# IC Corporation

## RECALL NOTICE

**IC CORPORATION RECALL # 02302**  
**NHTSA RECALL # 02V-200**

**August 2002**

### **Picture # 1 (NON-COMPLIANT)**

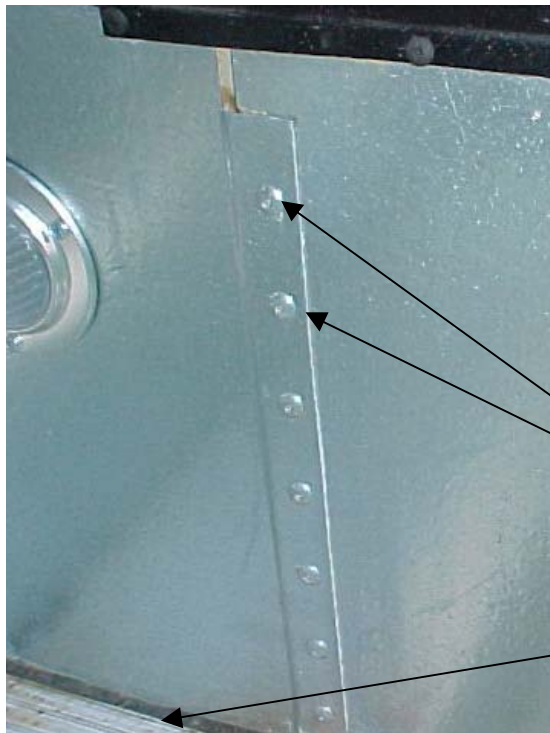
On some of the subject RE buses, if the vertical joints on the forward and rear side of the stepwell are assembled with rivets only, at a spacing of about two inches, the stepwell is incorrectly assembled and will not meet joint strength requirements per the above regulation. See pictures below that show the location and types of joints.

**Picture of riveted vertical joint on the forward side of the entrance door stepwell that reaches from the second step to the floor trim. This same joint is duplicated on the rear side of the stepwell. This picture shows the vertical joint assembled with rivets at a spacing of about two inches and does not meet the requirements of the regulation.**

If the joint is assembled with rivets spaced at approximately two inch increments (no additional screws or rivets) the joint must be repaired (reference Picture # 1). Follow the repair procedures stated below.

This repair procedure involves adding approximately 26 screws, (13 per side) to the vertical joints. No special tools are required. Pilot holes must be drilled prior to installing the screws using a 3/16-inch (#10) bit. Screws are to be located as follows. Insert one screw approximately 1 inch above the top rivet but no closer than about ½ inch from the top edge of the metal piece on the forward joint and not to interfere with the floor trim

piece on the rear side of the stepwell. Then insert two screws evenly spaced between the existing rivets.
